**MONTGOMERY COUNTY HISTORIC PRESERVATION COMMISSION**  
**STAFF REPORT**

<b>Address:</b>	13 Grafton Street, Chevy Chase	<b>Meeting Date:</b>	10/14/2020
<b>Resource:</b>	Contributing Resource <b>Chevy Chase Village Historic District</b>	<b>Report Date:</b>	10/7/2020
<b>Applicant:</b>	Norah & Diogo Coelho (Doug Mader, Architect)	<b>Public Notice:</b>	9/30/2020
<b>Review:</b>	HAWP	<b>Staff:</b>	Dan Bruechert
<b>Case Number:</b>	35/13-20DD	<b>Tax Credit:</b>	n/a
<b>PROPOSAL:</b>	Porch Alterations, Building Addition, Hardscape alterations including new curb cut and parking pad.

**STAFF RECOMMENDATION**

MUD ROOM & SIDE PORCH - PLAN & ELEVATIONS  
DETAILS & MATERIALS

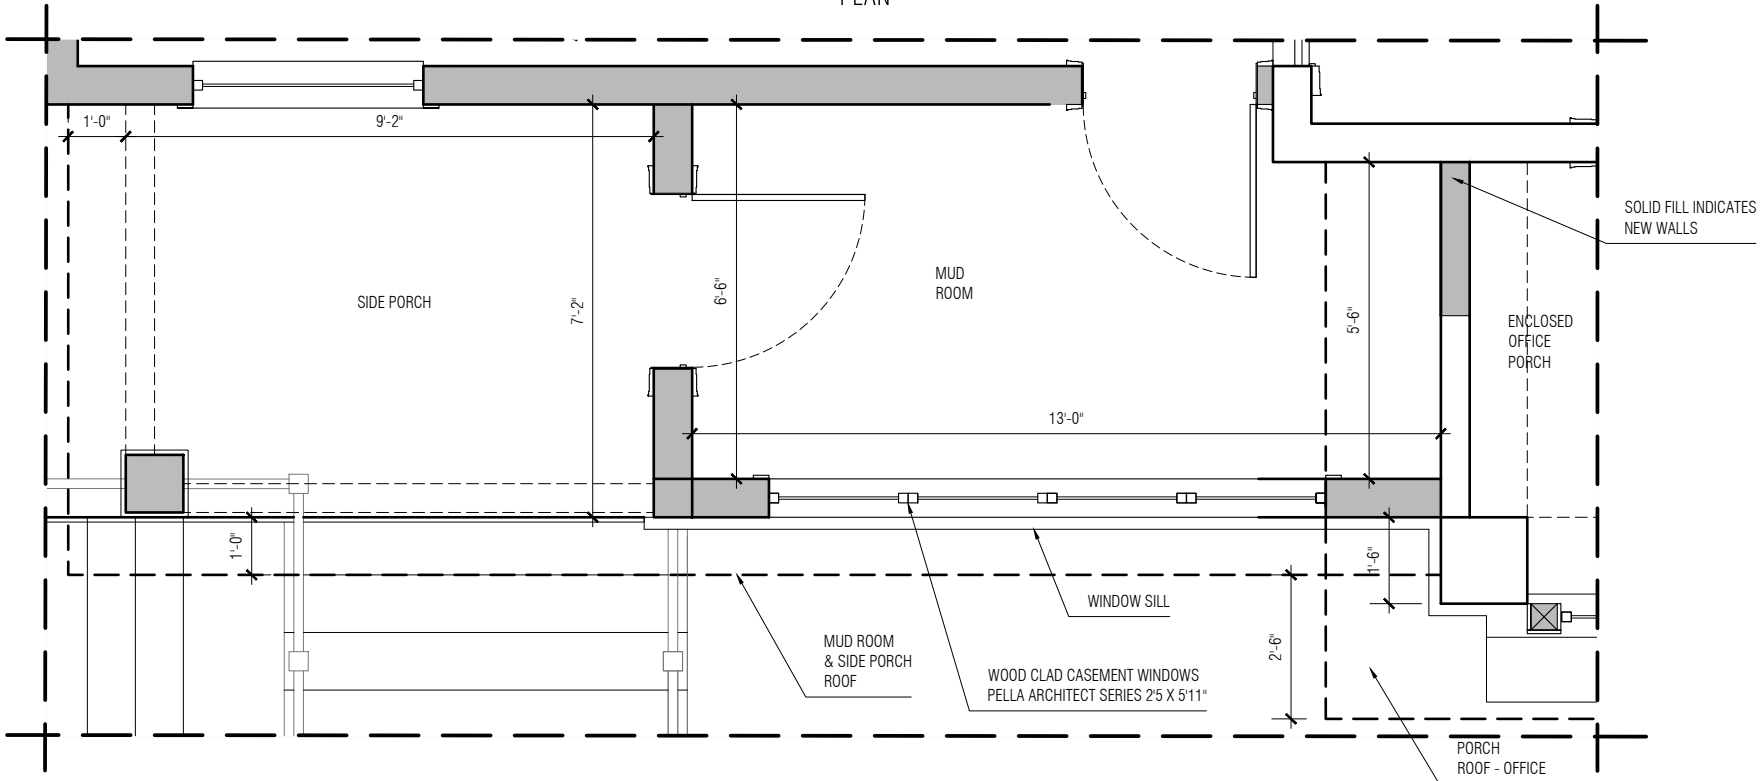
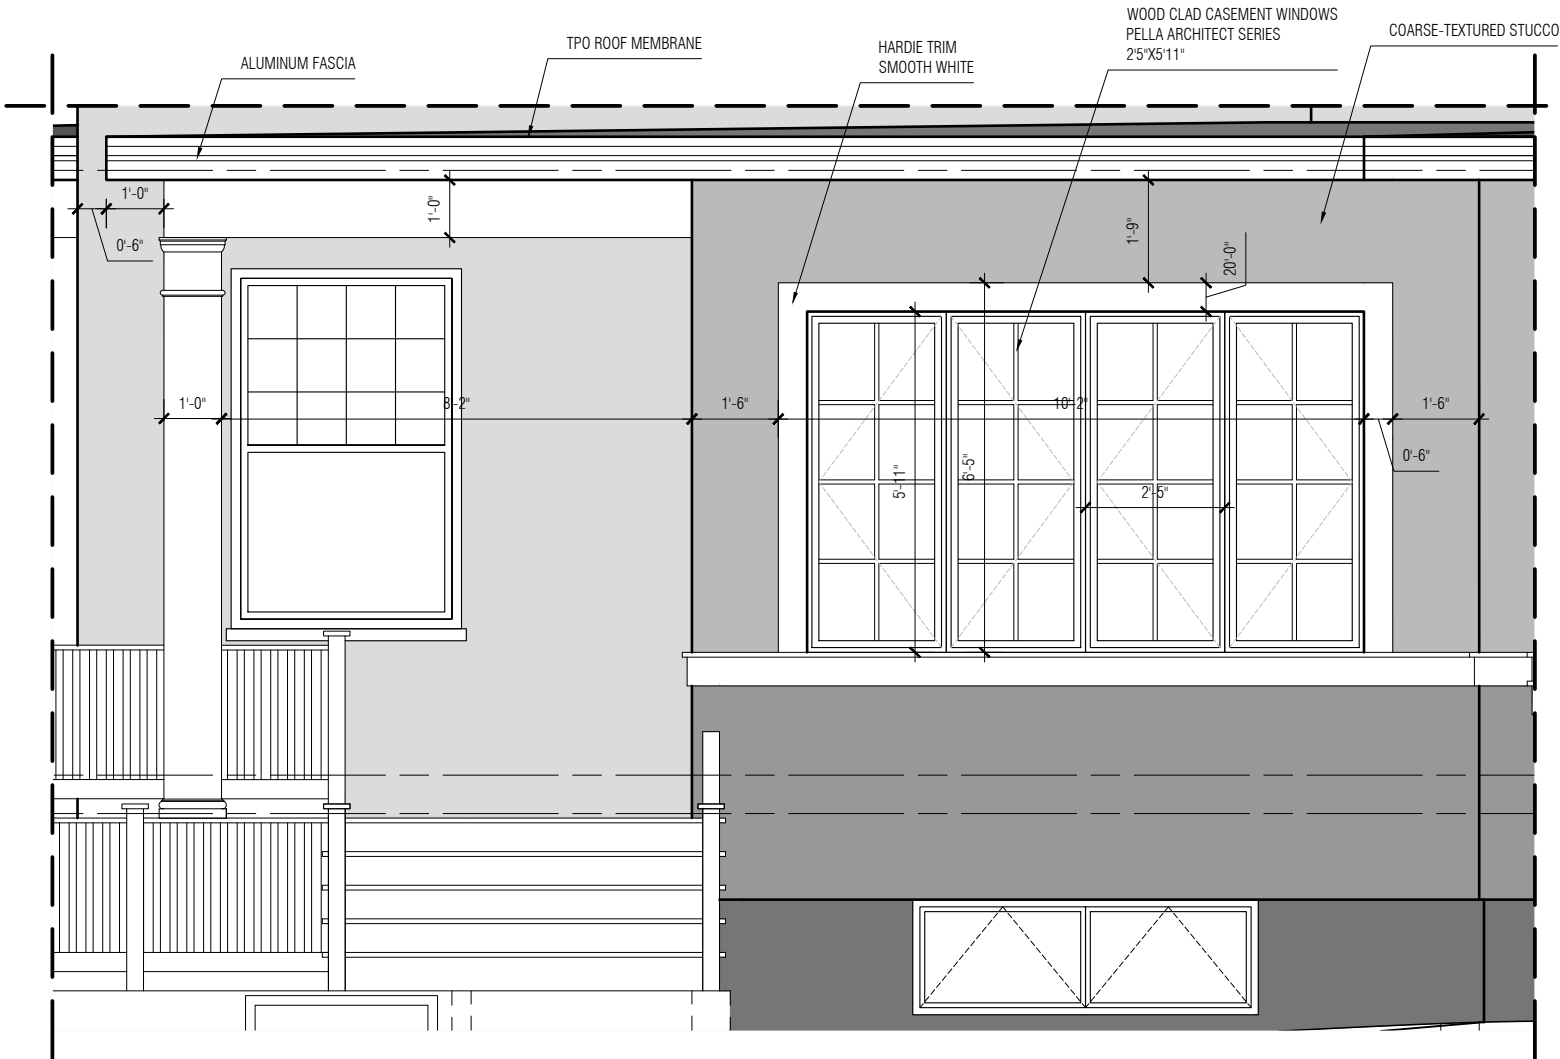
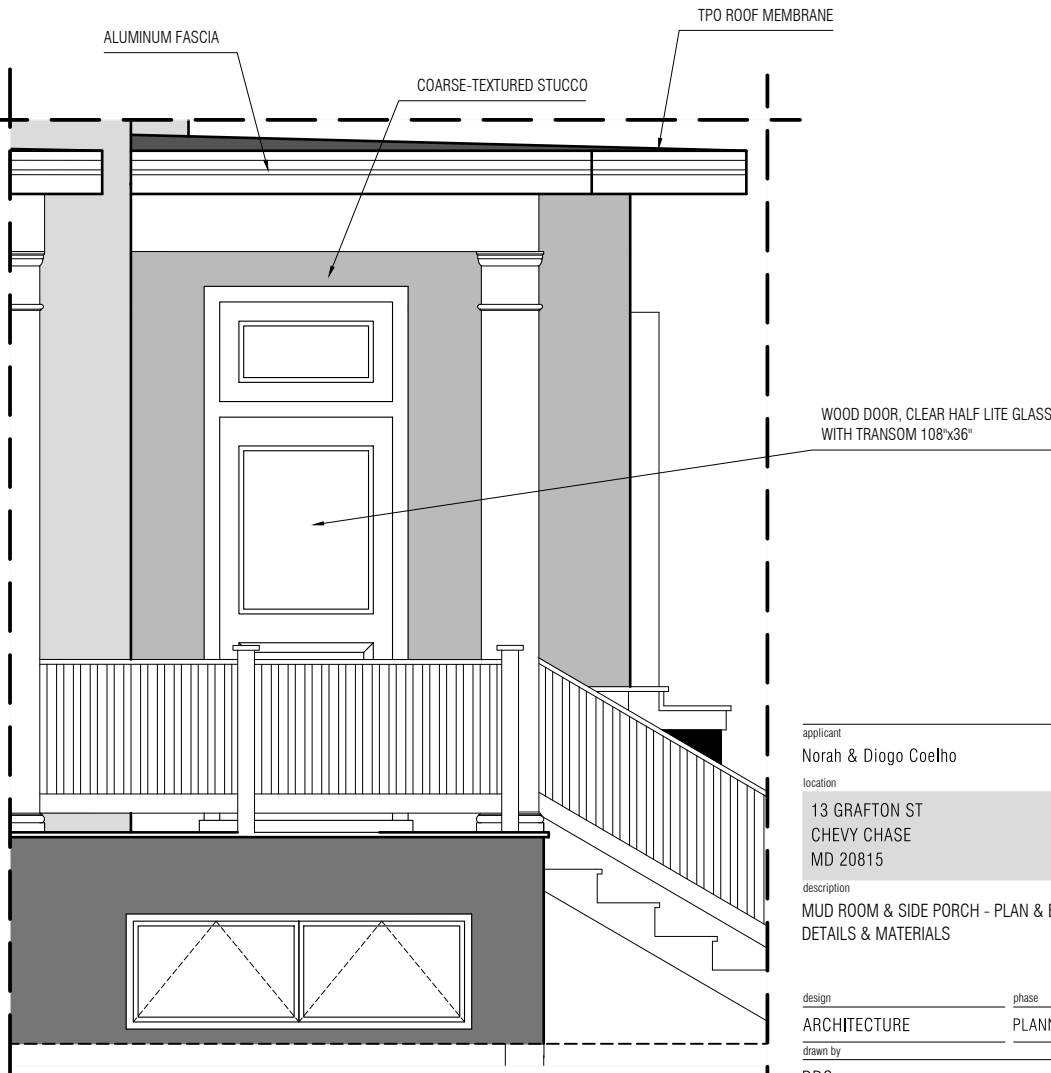
The applicant proposes to install a first-floor mudroom on the west elevation behind the side porch. The mudroom will be inset by 1' 6" (one foot, six inches) from the wall plane of the side porch to reduce its visual impact. The exterior treatment of the mudroom will match the stucco, casement windows, and flat roof of the porch. At the preliminary consultation, the HPC found the previous design of the mudroom to be out of character with the house and an incompatible addition. Staff finds the revisions are in keeping

with the architectural character and style of the historic house and support its approval under the *Design Guidelines* and 24A-8(b)(2).

13 GRAFTON ST, CHEVY CHASE  
RETAINING WALLS  
PROPOSED

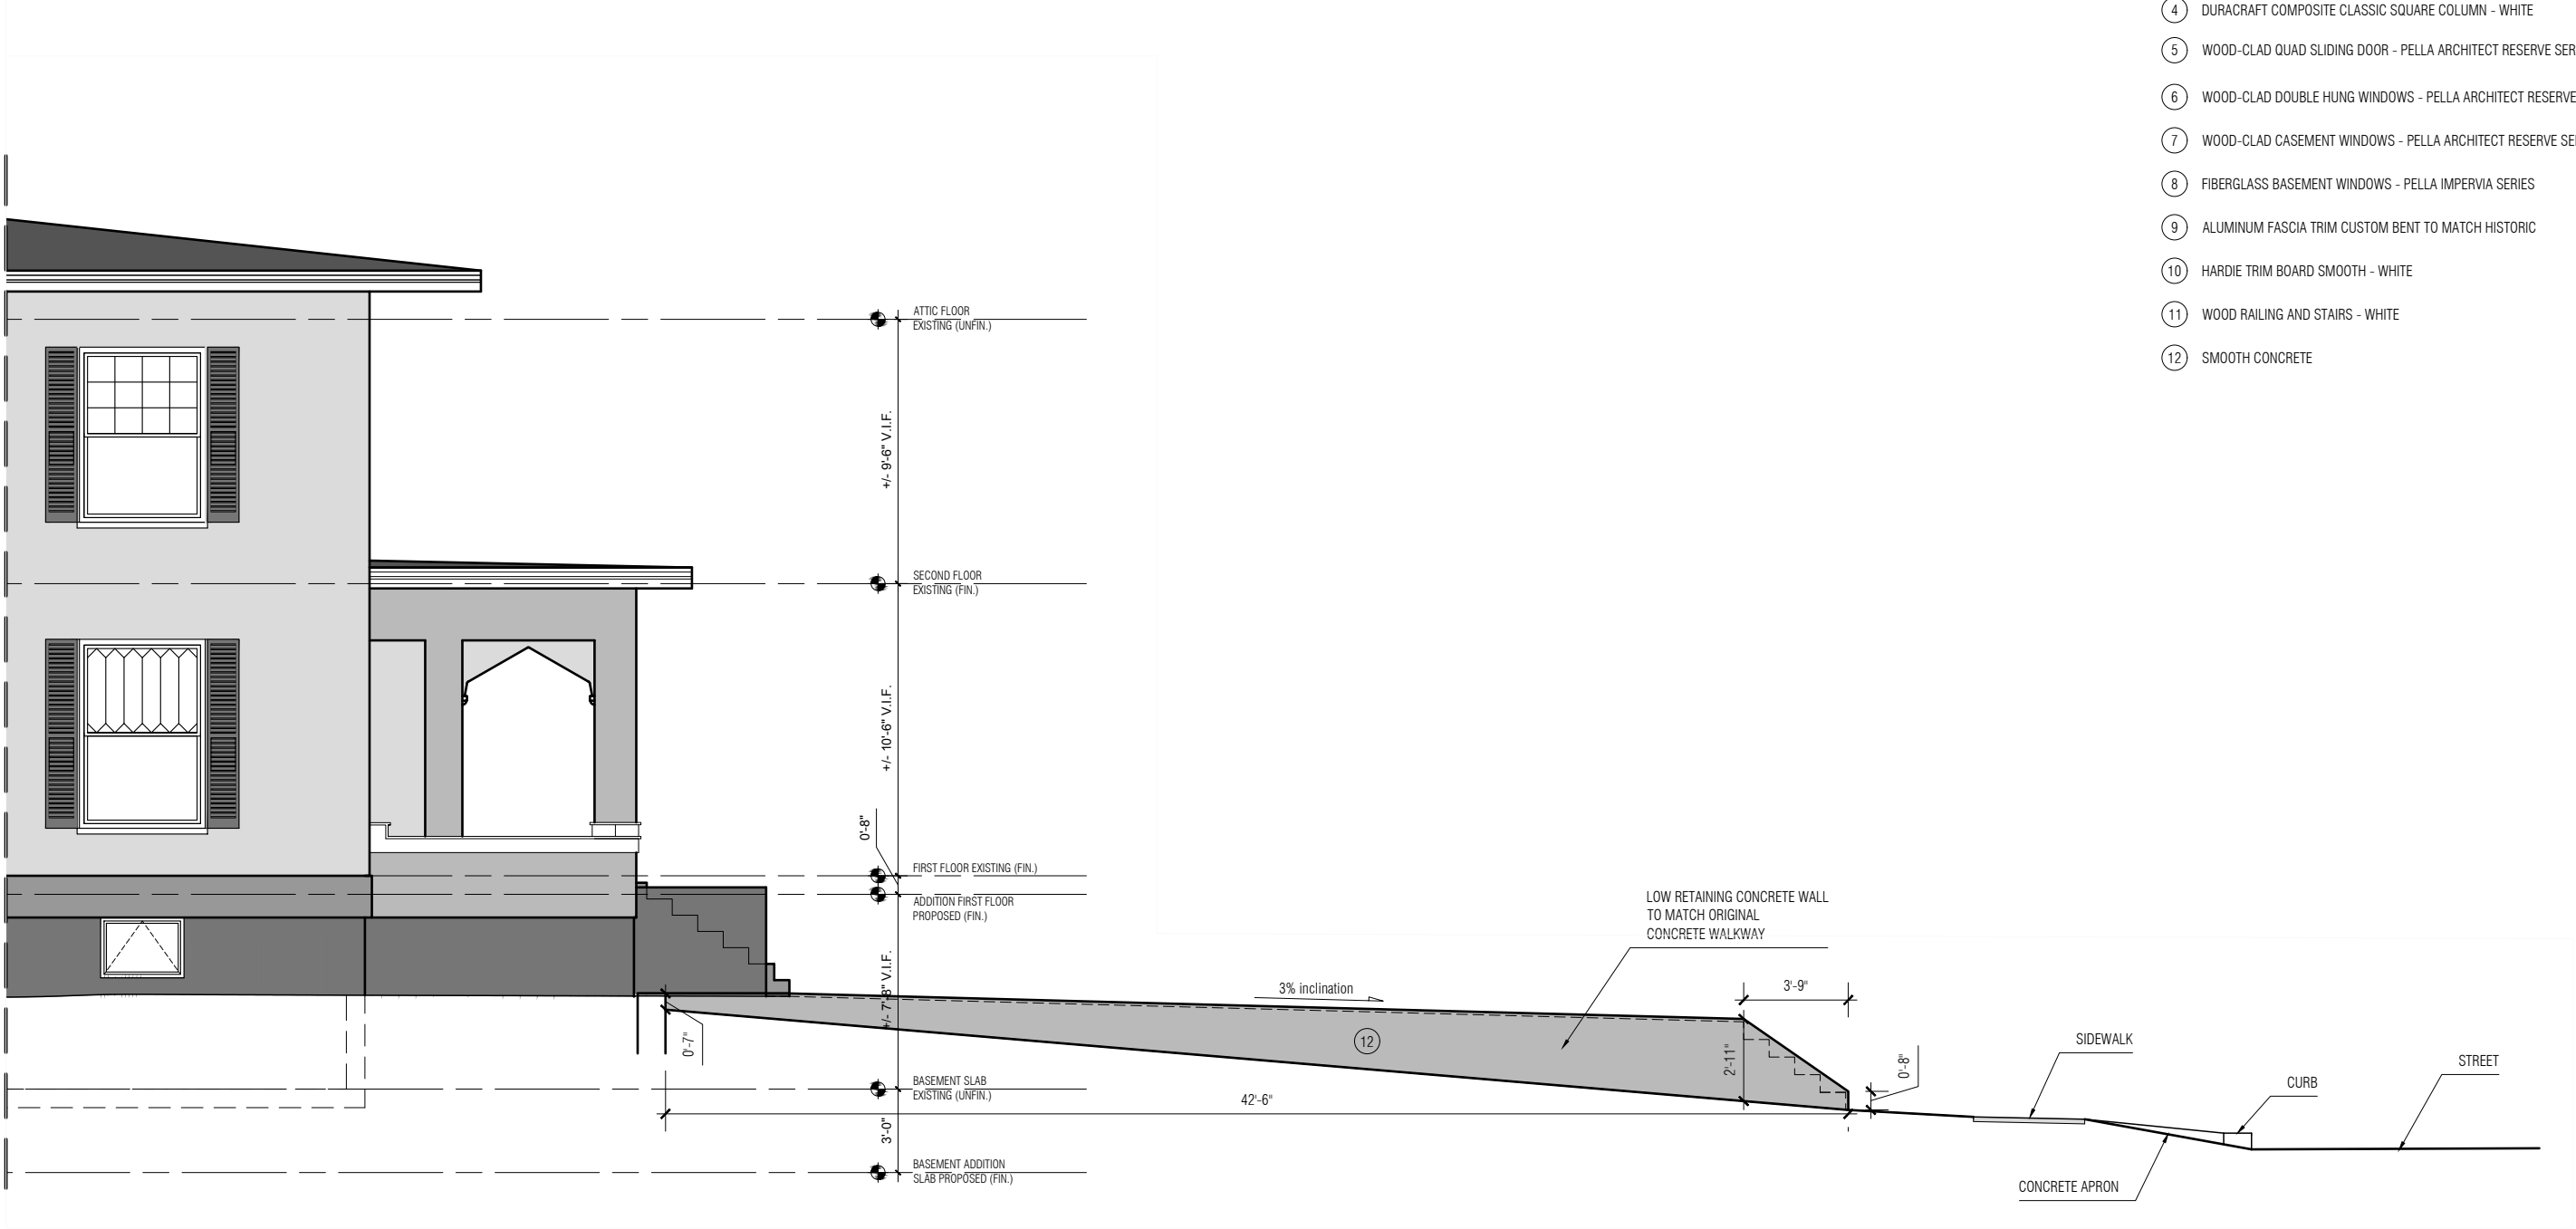
In the front, to the left of the house, the applicant proposes installing a new curb cut and driveway that extends to align with the front wall plane of the front porch. No trees in excess of 6" (six inches) d.b.h. will be removed to accommodate the proposed drive, therefore this work needs to be reviewed under lenient scrutiny. The drive will be constructed out of permeable blocks set in a herringbone pattern, with mulch edging; and will measure approximately 10' (ten feet) wide before it widens to 15' (fifteen feet) at the rear. Staff finds the proposed block is a compatible material. Due to the change in grade, a retaining wall needs to be installed. The proposed retaining will vary in height but will be a maximum of 24" (twenty-four inches) and will be constructed out of poured concrete. The note in the site plan states that it will "match the original concrete walkway." More specifications for the material were not provided. Staff finds that a historically-appropriate concrete would be a compatible material. However, due to the jarring appearance of modern white concrete, Staff recommends the HPC include a condition on their approval of this HAWP that the concrete retaining wall needs to match the tint and aggregate composition of the historic concrete. Final approval authority of this condition can be delegated to Staff to ensure conformance.

While the proposal will effectively serve as a parking pad because it does not extend to the rear of the property, its form and placement are consistent with the appearance of a driveway. The proposed hardscape alterations will result in a reduction in lot coverage. Staff recommends approval of the hardscape alterations under the *Design Guidelines* and 24A-8(b)(2) and (d).

1. The concrete mix proposed for the retaining wall needs to match the historic in tint and aggregate content. Final approval authority for this condition is delegated to Staff to confirm this condition has been met.
